SERVICE BULLETIN

SB No. 131 Issue No. 1

TITLE INSPECTION FOR CENTRE CONSOLE FIXING SCREW FOULING
 ELECTRIC TRIM SYSTEM

FIG 1 - POSITIONING OF SCREWS ON CENTRE CONSOLE PORT SIDE

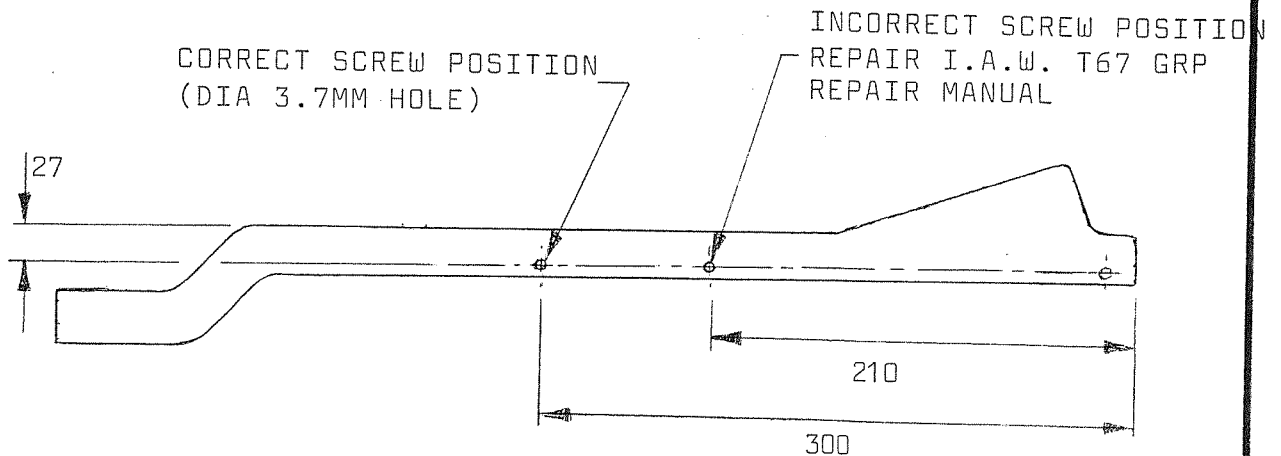
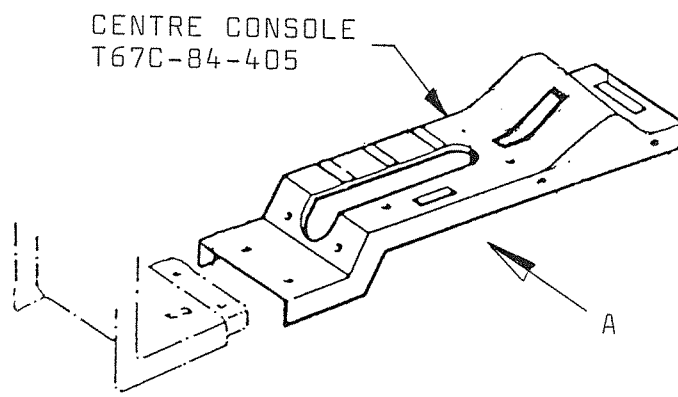
A case has been reported of a foul between the electric trim up limit microswitch and the centre console forward attachment screw on the port side.

Following investigation, it was found that the foul is due to incorrect placement of the centre console, left hand forward attachment screw.

1. Remove seat cushions.
2. Inspect L/H side of centre console and establish whether forward attachment screw centre is 300mm (11 13/16") from the rear attachment screw centre (correct position) or 210mm (8 1/4") from the rear attachment screw centre (incorrect position). Ref: Fig. 1 View on Arrow A.

3. (i) If screw was in incorrect position (210mm) check whether a foul has occurred, by inspecting the electric trim up limit microswitch (forward switch) and wiring for any chafing damage.
 (ii) If chafing has resulted in significant damage, renew appropriate components as required. Ensure that wiring is routed well away from any possible chafing points.

4. Remove centre console. Remove hole at 210 (8 1/4") by standard repair (Refer T67 GRP Repair Manual) and if required drill 5.1dia hole at 300 (11 13/16") position. Ref: Fig. 1 View on Arrow A.
